# FEC degrade signaling

# Consensus View on how FEC degrade signaling should work

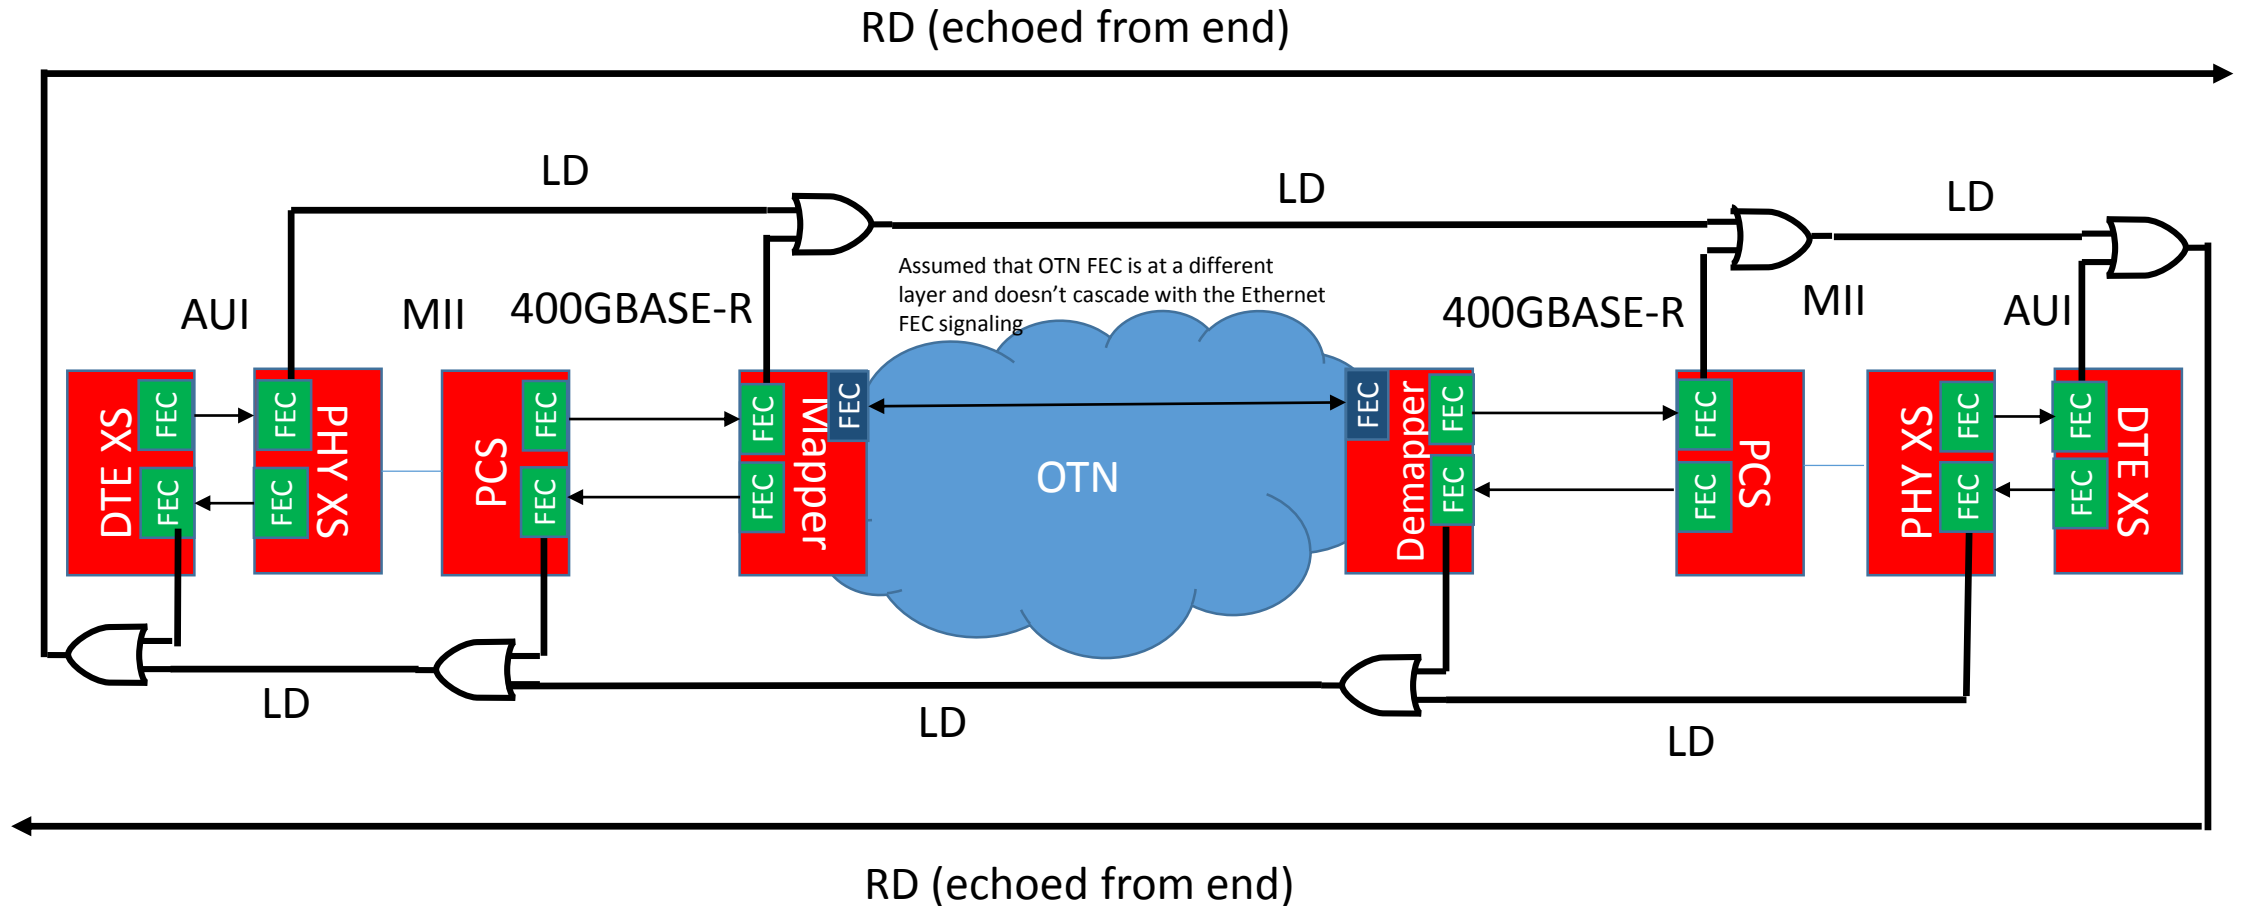
OTN mapper contribution to FEC degrade signaling is for ITU to decide, but LD, RD must be propagated whether or not the FEC decoder in the OTN mapper contributes to the accumulated LD status

LD and RD passed in AMs in AUI or Ethernet link, out-of-band to adjacent sublayer across MII

Drawback in description: PCS has different logic depending on whether it is directly below an RS or XS
